Recall Bulletin

PRODUCT SAFETY RECALL

SUBJECT: Replace Ignition Key

The service procedure section has been revised to include an important caution statement and a replacement key modification procedure. Discard all copies of bulletin 14133.

3817005

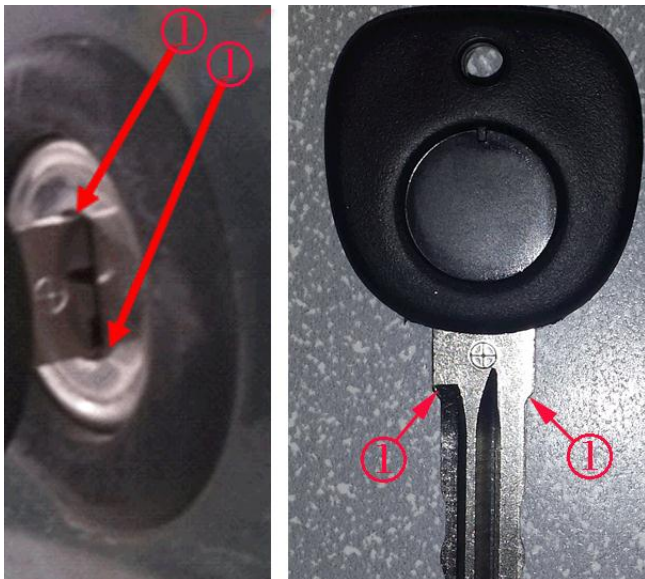
For the Saturn Ion only, if the replacement key profile is wider near the key head than the original equipment manufacturer (OEM) key, it may only work in the ignition lock cylinder and not in the doors or trunk. The replacement key may require modification BEFORE it can be used to open a vehicle door or trunk. Perform the *Key Modification* procedure in this bulletin if the replacement key will not open the doors or trunk of the vehicle.

Note: Without the modification, the key stops on the shoulder and will not fully enter the key lock cylinder. Refer to the photograph.

1. Using a file, remove the extra width of key near the over molded head as shown in blue (1) in the photograph above. Removing this material makes the width of the key 8.3mm (same as the OEM key) rather than 10mm. This will allow the key to enter fully into the door and trunk lock cylinders.
